## IEEE P802.11

**Addition of a Key ID Field**

**Summary**

Figure 5-4: Construction of expanded WEP MSDU

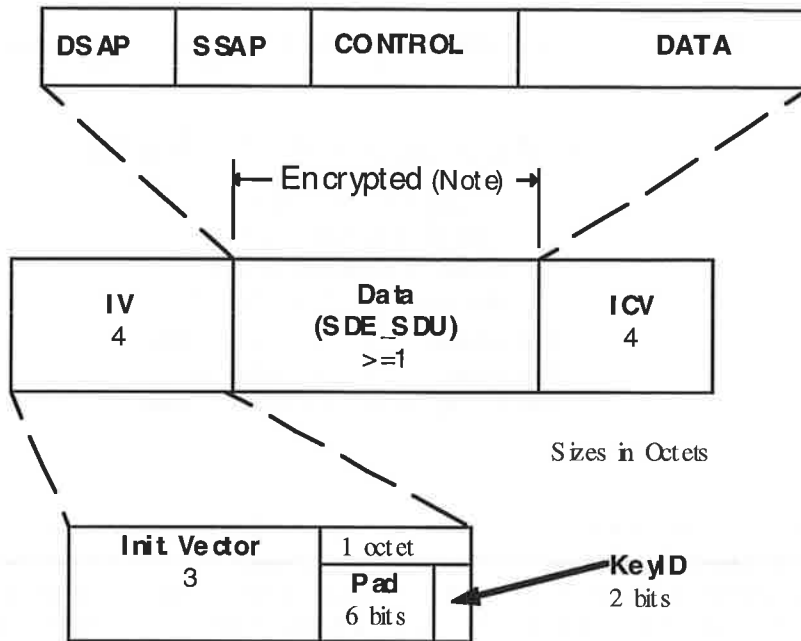
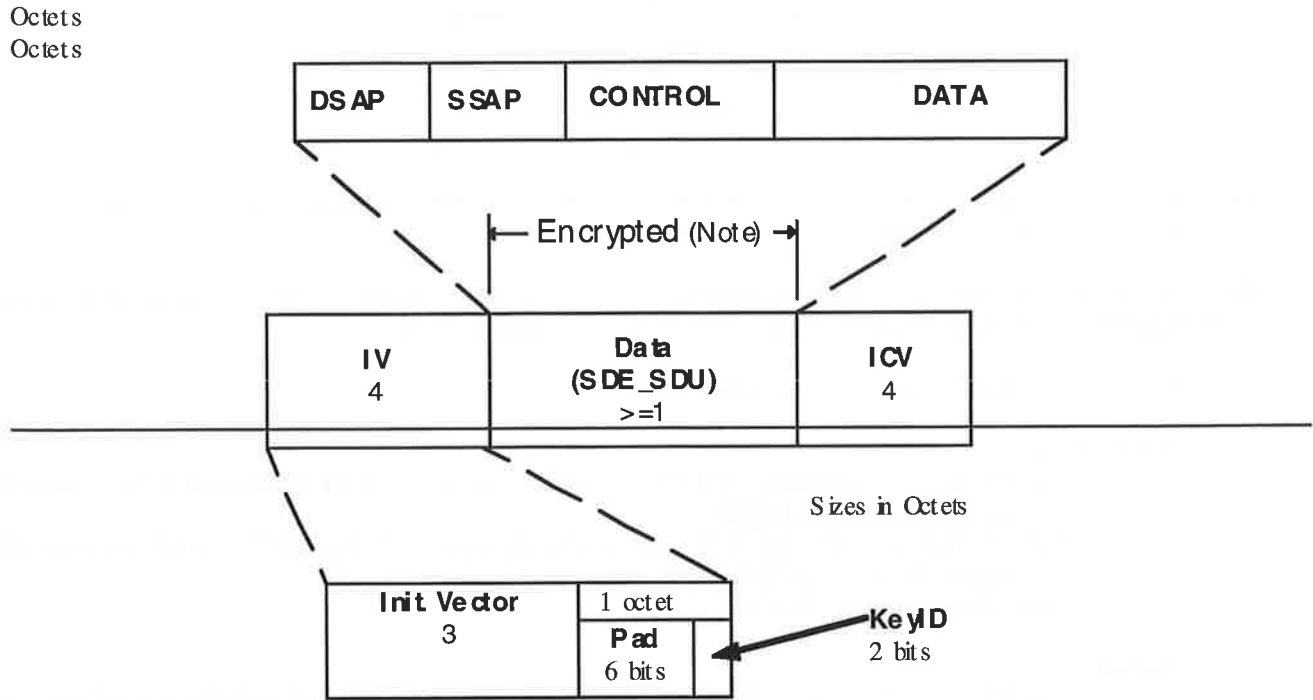
The WEP ICV = 32 bits. The expanded MSDU shall include a 32 bit IV field immediately preceding the MSDU. This field shall contain ~~three~~<sup>two</sup> sub-fields: A 3-octet field that contains the initialization vector, a ~~2-bit~~<sup>2-bit</sup> KeyID field, and a ~~6-bit~~<sup>4-bit</sup> pad field to maintain even-octet alignment of the encrypted payload. The KeyID field contents select one of four possible secret key values for use decrypting this MSDU. Interpretation of these bits is discussed further in section 5.3.2. The contents of the pad field shall be zero. The KeyID occupies the two least significant bits of the last octet of the IV field, while the pad occupies the six most significant bits of this octet.

Note: The encipherment process has expanded the original MSDU by 8 Octets, 4 for the Initialization Vector (IV) field and 4 for the Integrity Check Value (ICV). The ICV is calculated on the Data field only.

Note: The encryption process has expanded the original MSDU by 8 Octets, 4 for the Initialization Vector (IV) field and 4 for the Integrity Check Value (ICV). The ICV is calculated on the Data field only.
